**Monks Orchard Residents'  
Association  
Planning**

18<sup>th</sup> December 2023

Reference:	23/03978/FUL
Application Received:	Fri 20 Oct 2023
Application Validated:	Thu 30 Nov 2023
Address:	211 Wickham Road Croydon CR0 8TG
Proposal:	Demolishing of ancillary storage outbuilding area attached to the shop situated at the rear garden of 211 Wickham Road CR0 8TG and the erection of a detached building consisting of 1 No, three bedroom 4 Person self-contained unit and 3 Nos, 1 bedroom, 1 Person self-contained unit.
Status:	Awaiting decision
Consultation Expiry Date:	TBA
Determination Deadline:	Thu 25 Jan 2024
Case Officer:	Christopher Grace

### Google Earth Image of Location of 211 Wickham Road exceeding 800m from nearest Tram/Train Station and exceeding 800m from the nearest District Centre.

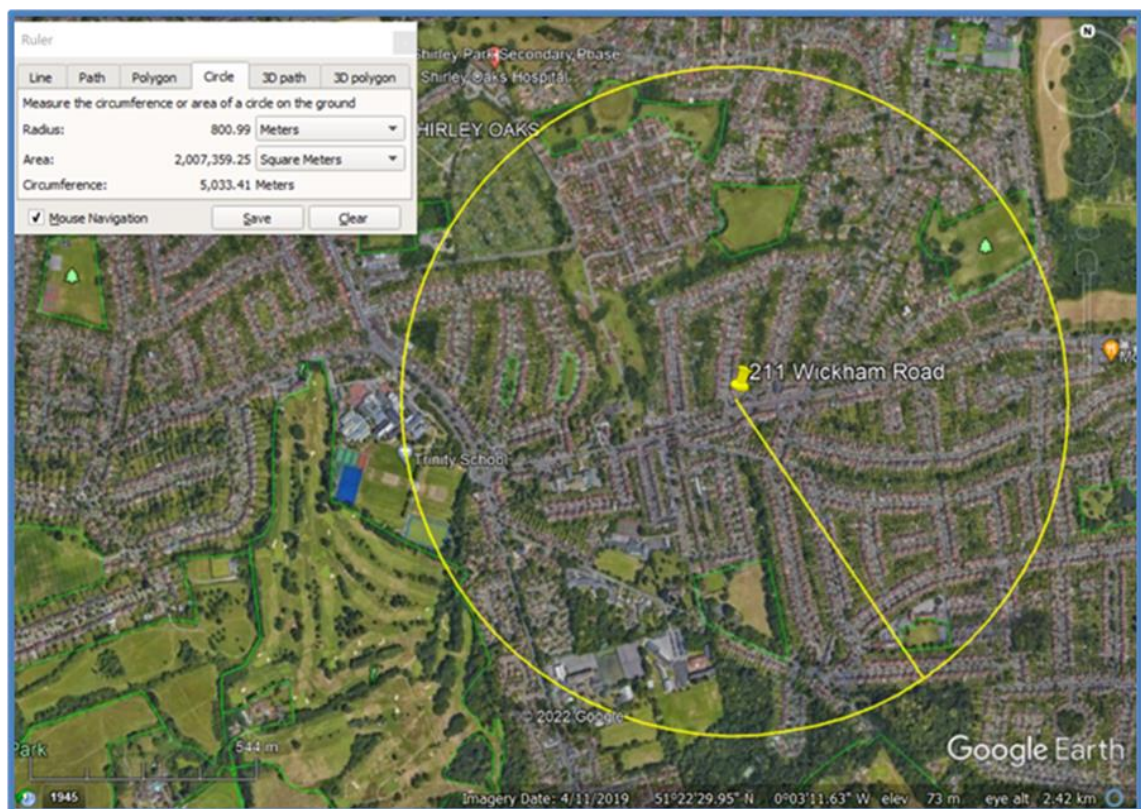
2.3.1.2 The Google Earth Image above illustrates that **211 Wickham Road** is greater than **800m** from any **Tram or Train Station** or a **District Centre**. **Shirley is a Local Centre, NOT a District Centre**. As the Local **PTAL is 2** i.e., <PTAL 3, the location of **211 Wickham Road** is inappropriate for *“Incremental Intensification”* as defined by the **London Plan Policy H2 Para 4.2.4**.

**Comparison of Post Code Residential Density & Proposal Residential Density and required supporting PTAL.**

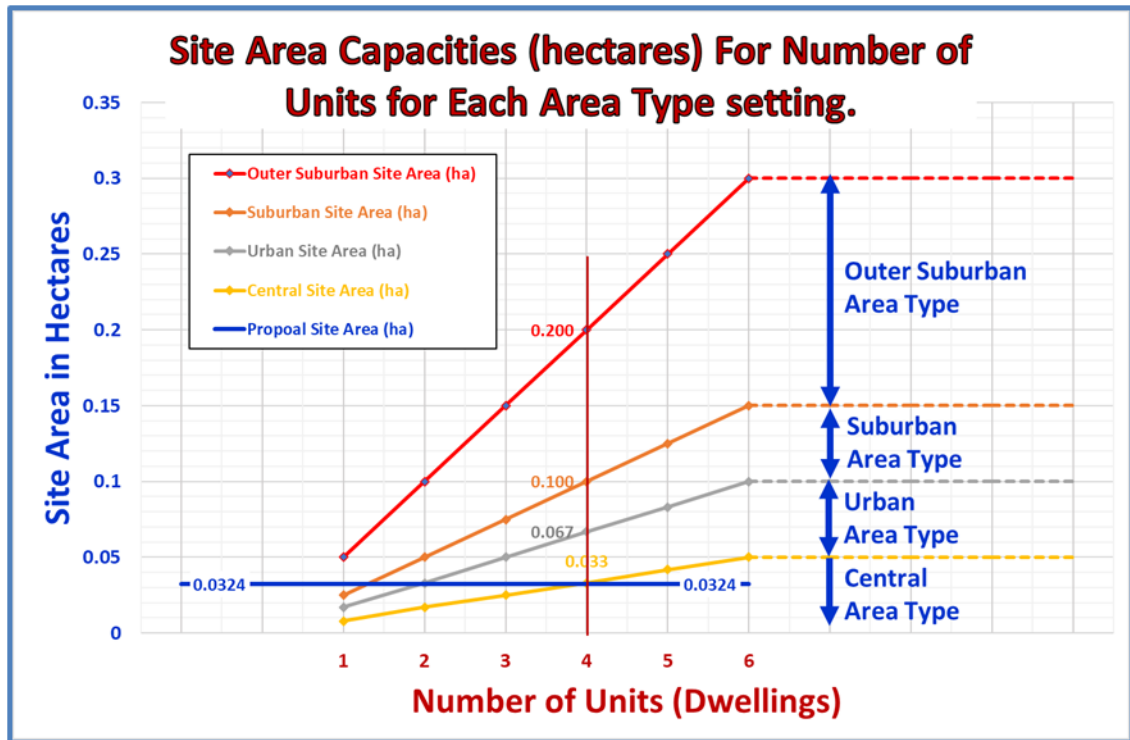
$$\text{Application Residential Density} = y = 216.05 = \left( \frac{283.2 - 47.2}{6} \right) * x + 47.2$$

$$\therefore x = \text{PTAL} = \frac{216.05 - 47.2}{39.33} = 4.293 \approx 4.29 \text{ PTAL}$$

$$\text{Residential at PTAL 2 Density} = y = \left( \frac{283.2 - 47.2}{6} \right) * 2 + 47.2$$

$$\therefore \text{Residential Density} = y = 39.33 * 2 + 47.2 = 125.87 \text{ bs/ha}$$
